AUDIT REPORT OF "NORTHERN EAST-WEST HIGHWAY PROJECT" IMPLEMENTED BY REGIONAL OFFICE, DEPARTMENT OF ROADS, THIMPHU MINISTRY OF WORKS AND HUMAN SETTLEMENT

PERIOD: INCEPTION TO 30 JUNE 2017

Subject: Audit Report of "Northern East-West Highway Project" of Regional Office, Thimphu for the period from inception to 30.6.2017

Fig: 2.1 –Initial approved design and drawings

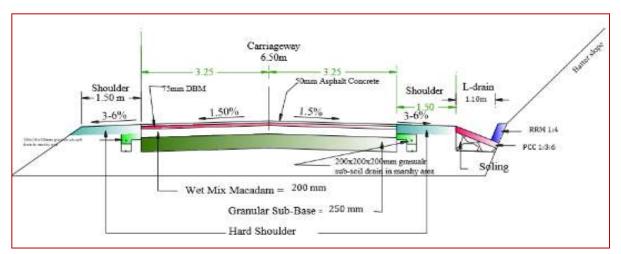
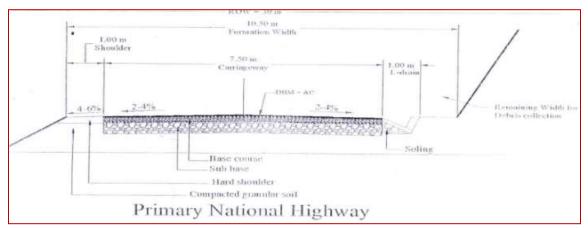
2.1 Increase of 1meter width carriageway due to change in design and drawing with resultant cost implication of Nu. 317.637 million

However, vide letter No. MoWHS/Sec-29/2015-2016/524 dated 16th October 2015, the Secretary, MoWHS had conveyed the meeting held on *16th June 2015* with the contractors and directed the Regional Offices for issuance of amendment to the contract agreements based on the decisions subsequently taken to increase the carriageway width from 6.5m to 7.5 m. Reasons for increase of carriageway width was found not documented.

In addition, vide letter No. DoR/ROL/16/15-16/481 dated 21/10/15, all Regional Offices were informed to increase the pavement width from 6.5 meters to 7.5 meters. In line with change order, the revised drawing developed and circulated by Design Division, DoR Thimphu was as depicted in the photograph below:

Thus, the increase of pavement width of 1m from the initial carriageway width of 6.5m to 7.5m after a time lapse of almost eight months from the dates of awards of contract works was irrational and inappropriate as it had not only distorted the drawings, estimates, BOQs, Projected Cost and funding modality but also adversely impacted the overall project cost by **Nu. 317,636,875.54** as summarized in table 2.1 below:

The Regional Offices in consultation with the Ministry should comment on the changes of drawings and technical specifications after the awards of contract works that had resulted in additional avoidable financial implication to the extent of **Nu. 317,636,875.54**.

It is thus evident that the change of designs and drawing and technical specification on the increase of Impavement width after award of contracts and during execution phase of contracts was an adhoc decision and was also not aligned to the approved design and technical specification of the Guidelines. The change of designs by doing away the 1.5mshoulder width between L-Drain and carriageway and reduction of 1.50 mto 1m at valley sides had resulted in compromising necessary safety measures and safety of commuters.

In addition, the extra financial burden to the government due to change is design and technical specification particularly due to increase of 1m carriage way alone after the contract awards amounted to Nu. 317.637 million (*Ministerial Level Committee were responsible for the changes*)

The Ministry should not only strengthen the Design Divisions for accurate designing of road structures but also institute a technical team to review project plans, designs, and specifications to ensure that the same are accurate and complete including verification of the accuracy of surveys for future projects as to prevent changes in designs as well as time and cost overruns.

Fig 2.5(1)- Design and Drawing aligned to Road Design Standard

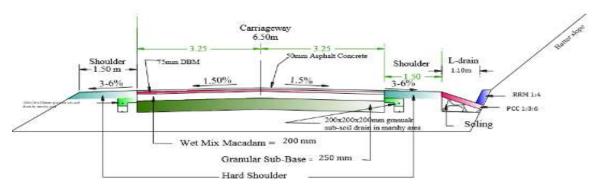
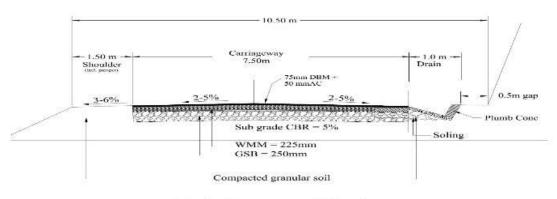
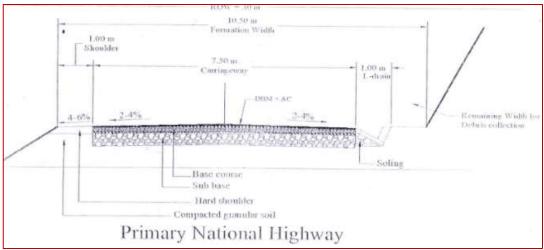
However, the Secretary, MoWHS vide letter No. MoWHS/Sec-29/2015-16/524 dated 16th October 2015 amongst others, directed all the Regional Offices on the decisions taken during the meeting held on *February*, 2016, after a time elapse of more than eight months from the commencement of the contract works, to increase pavement width from 6.5 m to 7.5 m and to issue amendment to the contract agreement signed with the contractors under respective jurisdictions.

In line with change order, the revised drawing was developed and circulated by Design Division, DoR Thimphu. However, during the course of the review of drawings implemented by the four Regional Offices, and site verifications, the audit team noted two (2) different drawings with difference technical specification for the same NEWH Up-gradation works.

It was noted that RO Thimphu and Trongsa were following one drawing and RO Lobeysa and Lingmethang were following a different as shown in Figure 1 & 2 below:

Thus, for the Primary National Highway, two different types of pavement drawings and specification were applied resulting in inconsistency in the implementation of Double Lanning works as well as non-adherence to the Road Design Standards specified in the *Guidelines on Road Classification System and Delineation of Construction and Maintenance Responsibilities* 2009.

Adoption of two different drawings with varying pavement specifications and non-adherence to the approved Road Design Standard indicated improper planning and lack of due diligence in the preparation of drawings and specifications. Such mismatches in technical specification of road works would inevitably result in execution of two different type of pavement works for the same NEWHdouble lanning works.

The ministry should review the circumstances leading to the implementation of two different sets of designs by the ROs besides instituting design review process to ensure consistent and uniform implementation of designs and drawing for similar projects in future.

In addition, the Ministry should also revisit the revised designs circulated to ROs, as the requisite gap between hillside and drains was found not maintained in majority of the work due to site specific and alignment problem of the drain works. Further, the Ministry should also relook on doing away of 1.5m Hard shoulders between the L-Drain and Carriageway in terms of risks towards safety of the commuters.

Fig: 2.6(2)- Revised design and drawing

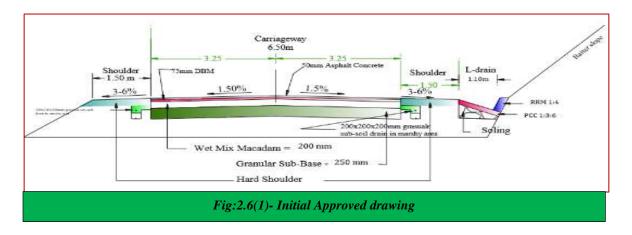
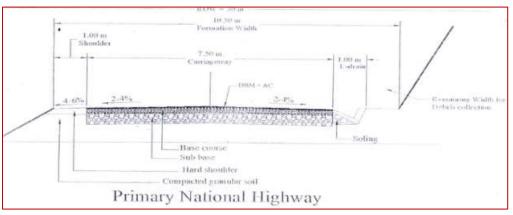
However, it was apparent from the records that based on the decisions taken during the meeting held in *February, 2016, after a time elapse of more than eight month from the commencement of the contract works,* drawings were found revised for different category of Road in Bhutan as depicted in the photograph below:

While the subsequent design and drawing had maintained increased carriage pavement width of 7.5m, other structural drawings were also changed from the initial designs and drawings as evident from the above photograph.

The above changes in the design and drawing not only resulted in extra financial implication to the government exchequer for increase of 1m carriage width to the extent of approximately Nu.317.637 million but also impeded timely completion of work due to grant of time extension for the increased scope of work as well as compromised safety measures by doing away Hard shoulders of 1.5m width between the L-Drain and Paved carriageway width including reduction of 0.5m hard shoulder at valley side. Besides, due to design changes, overall formation width of 10.5m were found not achieved as 1m width supposedly maintained for Debris collections between hillside and L-Drain were found not maintained in entirety for all stretches of the roads as majority of the L-Drain was found constructed attached to the hillside. Further, 1m shoulder width on the valley sides were also found not maintained as in some stretches of roads the pavement road were found executed at the edge of the road width.

As discussed in the exit meeting, the DOR in consultation with the Ministry should revisit the revised drawing for appropriate decisions and taking measures to address any technical flaws and ambiguities. Besides, the Ministry should also look in to the requirement of approval of Cabinet on the revised designs as it had deviated from "The Guidelines on Road Classification System and Delineation of Construction and Maintenance Responsibilities 2009".

Fig: 2.22- Initial approved design and drawing

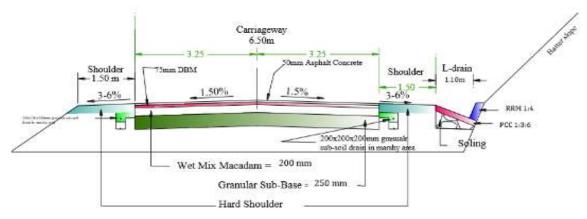
2.23 Irregular Change of pavement thickness with resultant inconsistency in the execution of pavement works

Northern East-West Highway being the Primary National Highway, both the initial and revised drawings has specified a total pavement thickness of 600mm as shown in the diagram and in the
